# Access Compliance Report Public Rights-of-Way (Curb Ramps)

| Main Street: SAUGUS_AVE                 |                              | Cross Street: WINTHROPE_ST |                                         | Location:       | NW |
| ADA ID: RPAT211026124350                | Ramp Type: Type 4 - Parallel | Initial Pass/Fail: Pass    | Overall Compliance: No                  | Severity Score: | 12 |

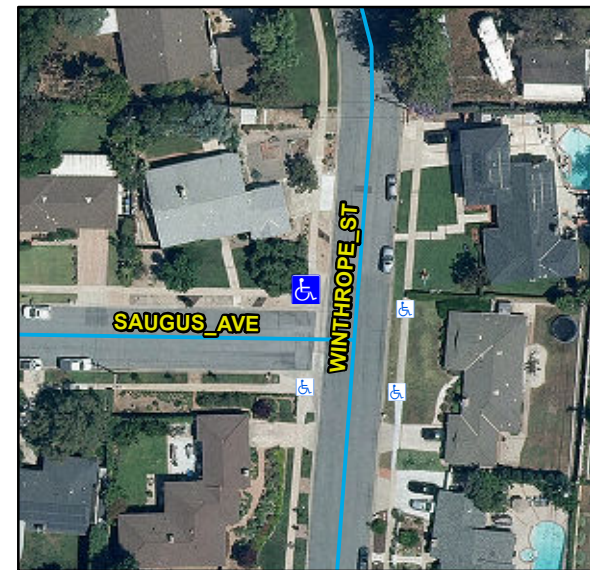
**R204.3, R304.5.3, R304.2.2-Perp, R304.3.2-Para, R305, STD 1115**

| Compliance | Description                   | Data       | Compliance | Description                   | Data |
|------------|-------------------------------|------------|------------|-------------------------------|------|
| Yes        | Ramp Cross Slope LT (%)       | 1.9        | No         | Ramp Cross Slope RT (%)       | 2.6  |
| N/A        | Landing Present               | Yes        | No         | DWS Provided                  | No   |
| No         | Landing Run Slope (%)         | 2.5        | N/A        | DWS Full Width                | N/A  |

**Remove & Replace Curb Ramp With Two New Directional Ramps or Equivalent.**
